# SLIM CHICKENS SITE PLAN

PARKER AND PINE FILING NO. 1, LOT 3

SITE PLAN  
**SLIM CHICKENS**  
SWC OF S. PARKER ROAD AND E. PINE LANE, PARKER, CO 80134  
**COVER SHEET**

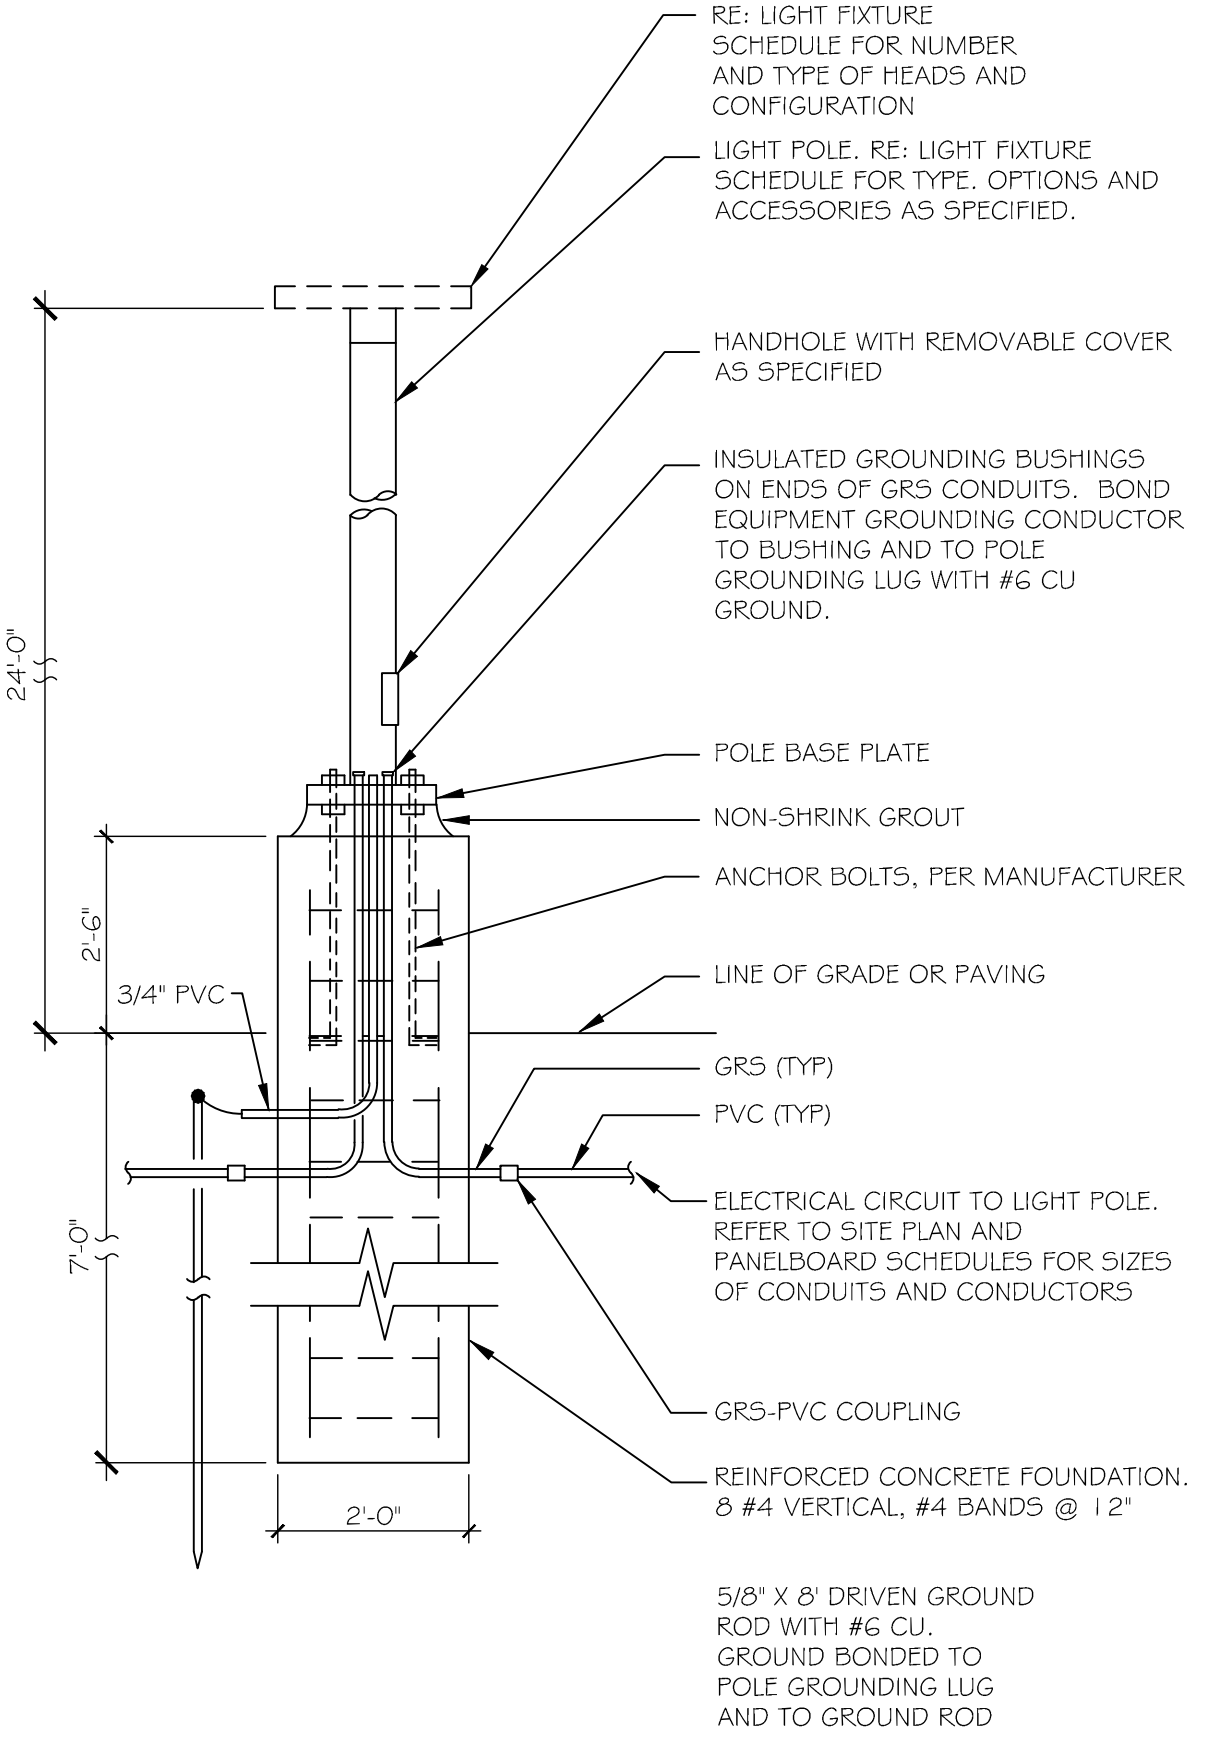
uniformity ratios have been added to the chart

Foot candles have been added to the north and NE edges of the property.

fixture finishes colors have been added to the schedule.
